Upper backcover 3D development progress

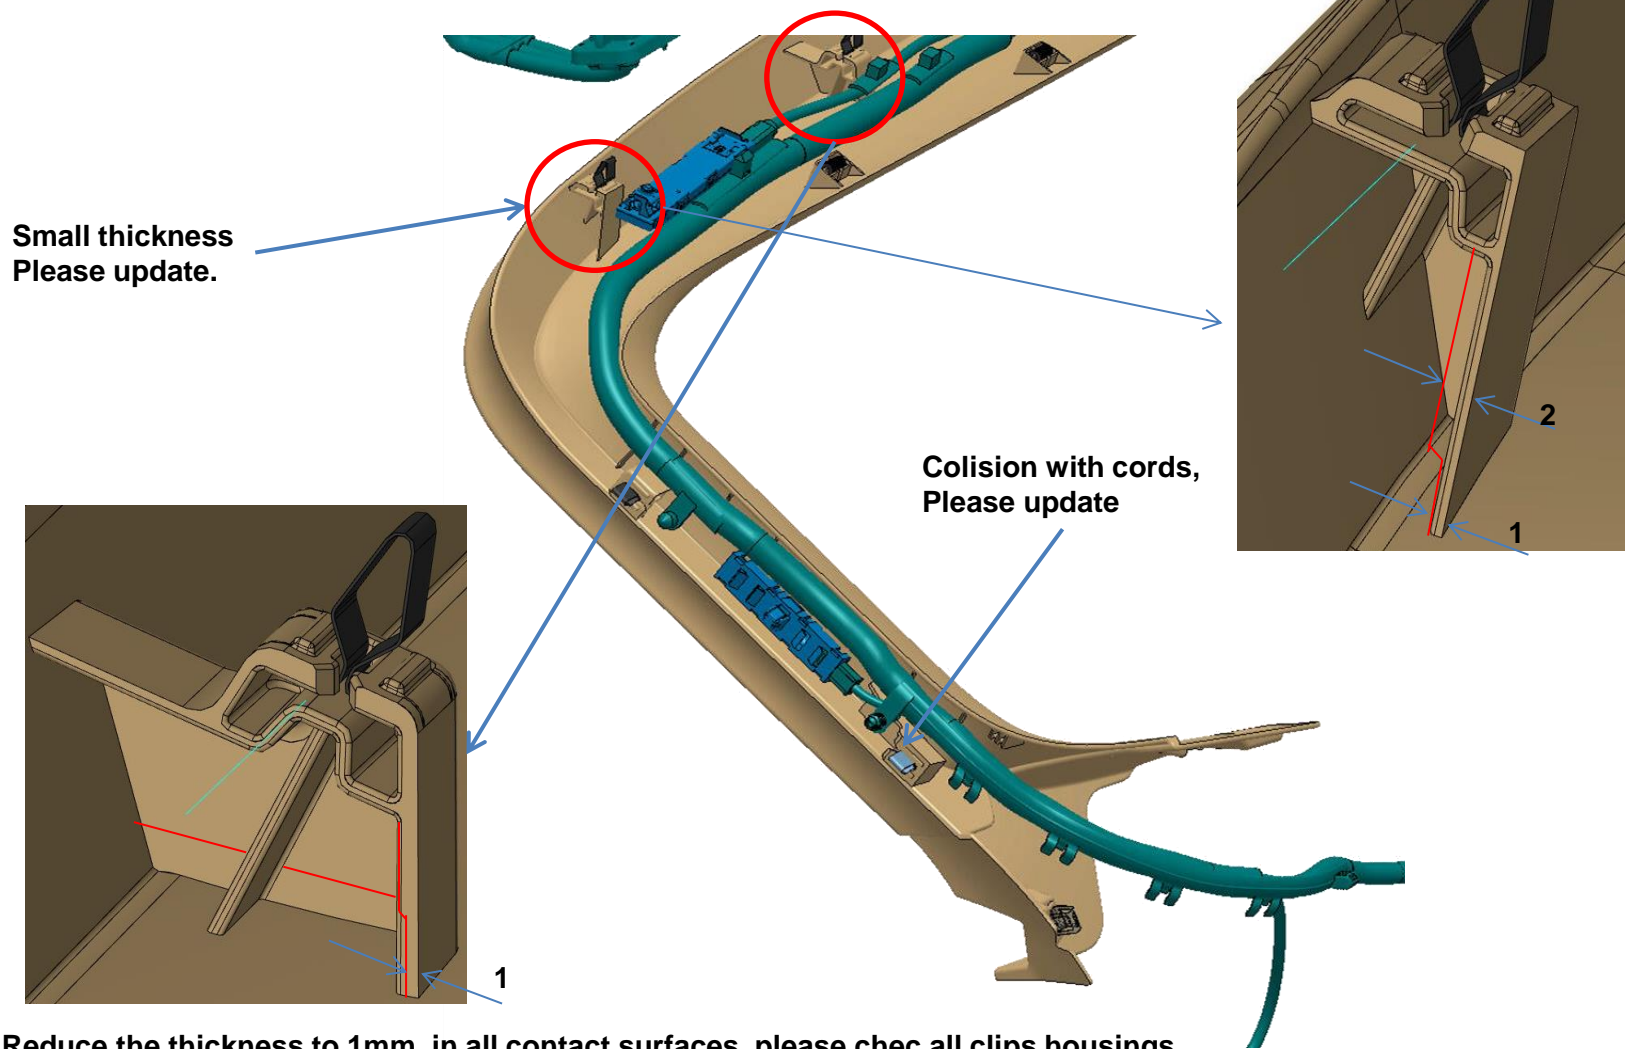
Reduce the thickness to 1mm. in all contact surfaces, please chec all clips housings
